Kellyville Station Precinct

Response to Submissions

Prepared for
Landcom

2.1 State Design Review Panel (SDRP) and the Government Architect NSW (GANSW) Comments dated 4 November 2019

Figure 12: Street setback plan

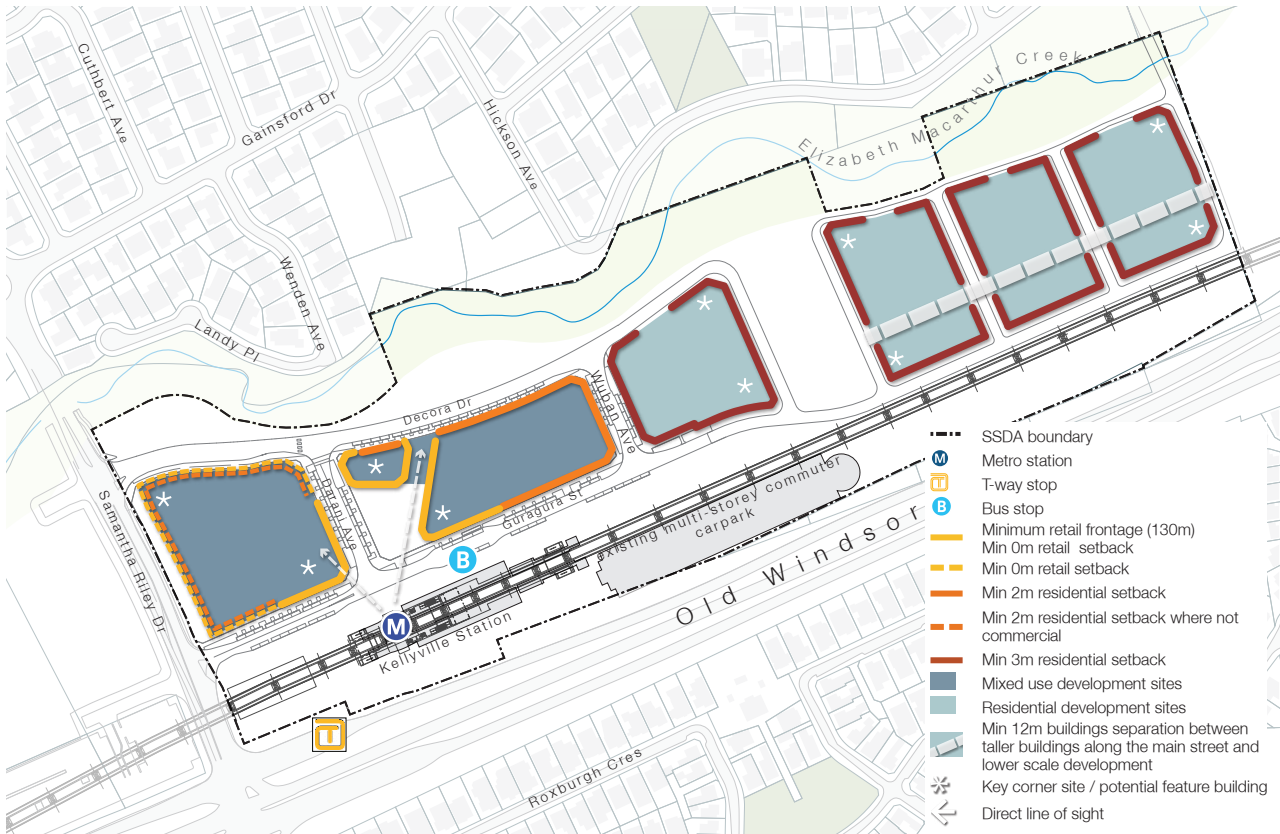
- The streets become much wider, with no qualitative contribution to the streetscape or improvement in amenity for residents
- The width of the communal open space in the centre of the block becomes narrow and equivalent to the width of the street.
- The communal courtyards are more overshadowed and will offer less amenity to residents
- There is a 7.5% loss of total GFA across the masterplan area

- The proposed minimum setback for residential flat buildings in the residential core has been increased from 2m to 3m. Sections 4.4.2 and 4.4.5 of the DG have been updated accordingly
- Section 4.4.3 of the DG (Setbacks) now also includes a table (included on the next page of this report) that stipulates different minimum setbacks for buildings of different heights to create more human scaled streets where the perceived height of buildings is diminished and to support a rich and varied streetscape
- Section 4.4.5 of the DG (Street Walls) has been reviewed to require a 4 storey street wall within the Residential Core, with increased setbacks along Elizabeth Macarthur creek (See Figure 11 below)

Figure 14: Proposed Street Wall and setback controls for the Residential Core. Top - Lot C. Bottom Lots D,E and F)

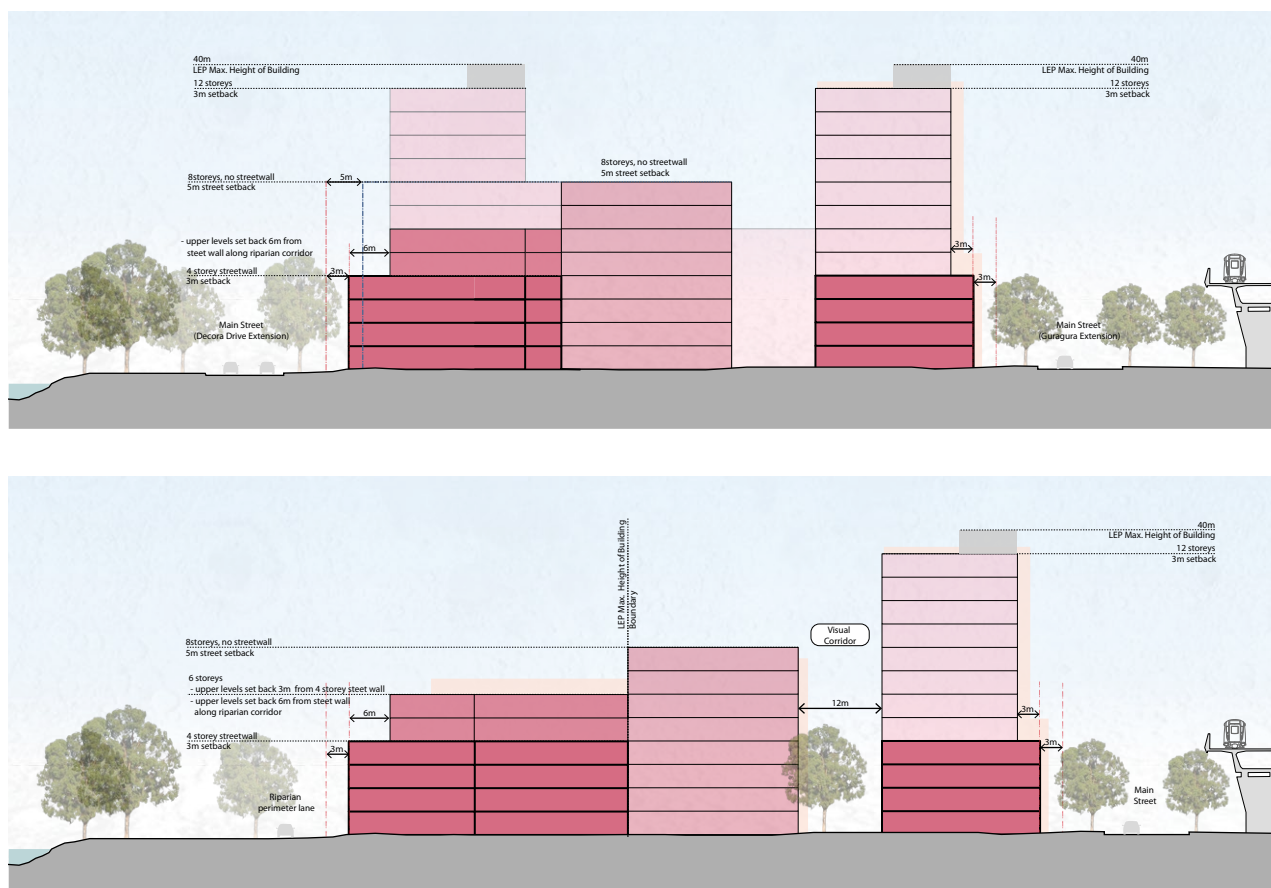
Clarification required regarding proposed building envelopes and if these are inclusive of plant and lift overruns. These features should not protrude about the maximum permissible building height unless fully integrated into the architectural roof feature design in accordance with Clause 5.6 of The Hills LEP 2012.

The DG (Section 4.2.1) has been reviewed to require a through site connection through Lot B and Section 4.4.6 has been amended to require a 3m deep setback, at least 6m wide every 50m to address the visual impact of any potential the podium (See Figures 2 and 6 above). It now also prescribes a maximum building length of 70m in the Residential Core Precinct that allows for two co-joined residential flat buildings with independent cores to accommodate with buildings oriented in an east-west direction to allow through-apartments that ensure that cross ventilation requirements of the ADG can be achieved.

As illustrated in the Figures 8 and 14 and above, the proposed height of buildings accommodates the total height of building, including lift over runs. Proposals at the next stage of planning will need to comply with the provisions of the LEP. The SSDA is not seeking additional height.
